PUMP BASIN & FORCE MAIN AS-BUILT PLAN
16 NASON HILL LANE
SHERBORN, MASSACHUSETTS
FOR
MIKE NEWMAN
16 NASON HILL LANE
SHERBORN, MA 01770

JOB No. 15,726
DATE: 2/21/18
SCALE: 1"=20'
SHEET: 1 of 1

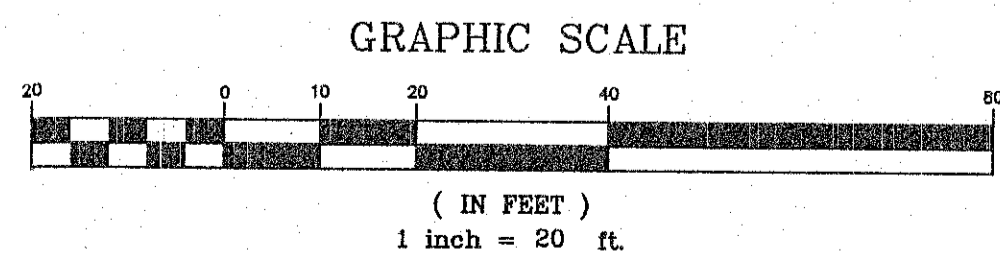
- PUMP NOT INSTALLED AT TIME OF INSPECTION. GLM WILL NEED TO INSPECT PUMP INSTALLATION ONCE COMPLETED.
- INSTALLER AND/OR APPLICANT MUST CONFIRM WITH ENGINEER THAT ONLY WASTEWATER FROM THE POOL HOUSE IS CONNECTED TO NEW PUMP BASIN.

NOTWITHSTANDING BACKFILLING OF THE SEPTIC SYSTEM OR FINISH GRADING OVER AND ADJACENT TO THE FORCE MAIN, THIS FIRM DID ON 2/2/18 & 2/21/18 INSPECT THE PUMP BASIN & FORCE MAIN, AND FOUND THEM TO BE SUBSTANTIALLY LOCATED AND CONSTRUCTED IN COMPLIANCE WITH THE TERMS OF THE PERMIT, THE REQUIREMENTS OF THE BOARD OF HEALTH, COMMONWEALTH OF MASSACHUSETTS TITLE 5 AND THE APPROVED PLAN DATED 3/22/16 & REVISED 5/2/16.
